DREHID WIND FARM AND SUBSTATION SID

Responses to Submissions and Observations

P25273-FT-XX-XX-RP-XX-0002

Figure 2-4: Zoomed-in, and full hardstand detail reproduction of Figure 10.8 from the EIAR

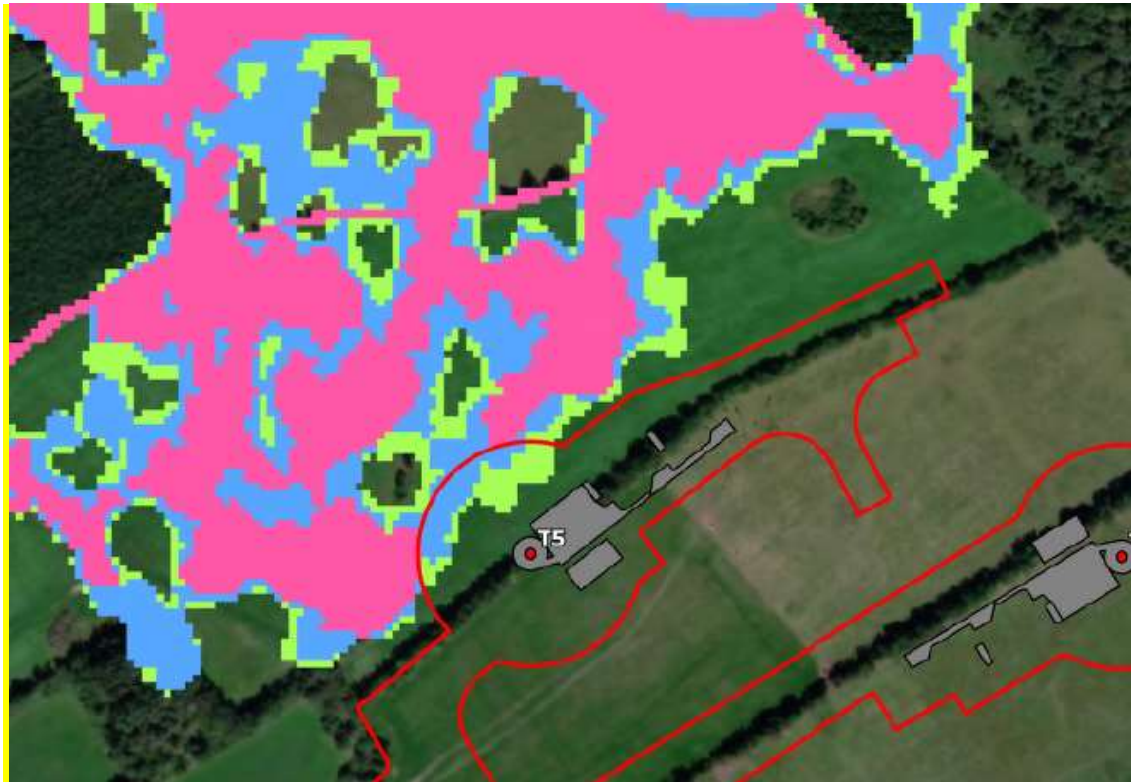
The Water Services Department state that T5 and T6 are within National Indicative Flood Map (NIFM) flood extents zone A and B. We would like to clarify that T5 is not within any of the NIFM flood extents (see Figure 10.8 of the EIAR). It is possible that the Water Services Department misinterpreted the redline boundary as the footprint of the infrastructure, as the redline boundary in the vicinity of T5 does lie within NIFM flood extents. For clarity, we have reproduced Figure 10.8 from the EIAR, this time including the details of the turbine hardstandings for avoidance of doubt of their extents, and zoomed to such a scale that it can clearly be observed that T5 does not lie within the NIFM flood extents.

It is true that the proposed location for T6 is situated within NIFM flood extents. Due to its location within indicative flood zones, a 2-D flood model was run for the area using HEC-RAS flood modelling software, and a high-resolution data terrain model (DTM) acquired in 2023. The flood model confirmed that flood extents for a 1-in-100 year flood event would extend over the T6 location, as shown in Figure 2-5:

As detailed within the EIAR, to mitigate against the potential for flood events impacting on the T6 turbine, the ground will be raised locally at the T6 location, so that the turbine foundation and hardstanding has a finished level that is at least 300 mm above the modelled flood level. The finished level of the hardstanding will be 79.5 mOD as can be seen on planning drawing P22-242-0300-0006, which exceeds the 300 mm above the modelled flood level.

Raising the ground locally to elevate the T6 foundation and hardstanding will displace a volume from the flood capacity in the area, and therefore flood “compensation” must be provided to return the flood capacity to the same as pre-development. This will be achieved by providing a “flood compensation area” immediately adjacent to the T6 hardstanding, as shown on planning drawing P22-242-0101-0033. The flood compensation area will comprise a depression in the local ground, excavated to 1.5 m below existing ground level, to cover an area as shown in the planning drawing P22-242-0101-0033 which will provide a compensation of flood capacity to cancel the volume displaced by raising the T6 foundation and hardstanding. The result of this is that flood extents in the local area are unchanged for a given flood event, as the capacity for the land to absorb flood water remains the same post-development.
